# 802.3cw D1.4 Comments #30-#39

## Interoperable Transmitter Metrics

Author - Mike A. Sluyski

March 28, 2022

# Comment #30: Error Vector Magnitude

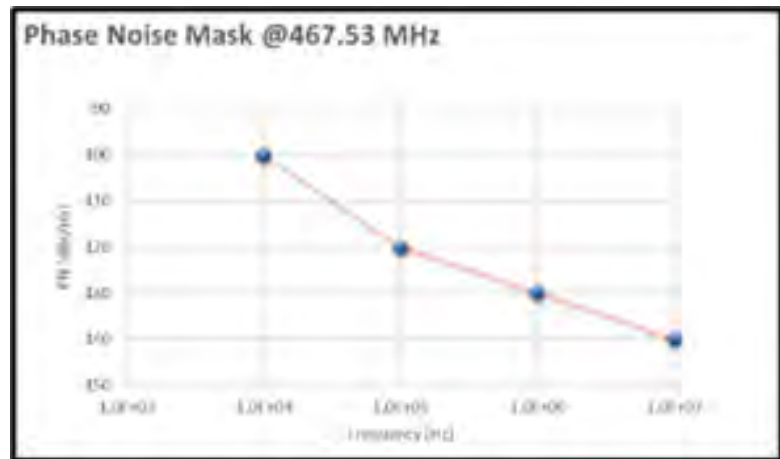
**Remove from Table 156-6 400GBASE-ZR transmit characteristics: Error Vector Magnitude (max)**

**Alternative to removal - Table 156-6 400GBASE-ZR transmit characteristics: Error Vector Magnitude (max)**

| Error vector magnitude (max) <sup>1</sup> | <under study><br>(See 156.9.10) | % |

<sup>1</sup>Error Vector Magnitude (max) is an informative Tx quality metric that is under study for future consideration. EVM is not a requirement for compliance.
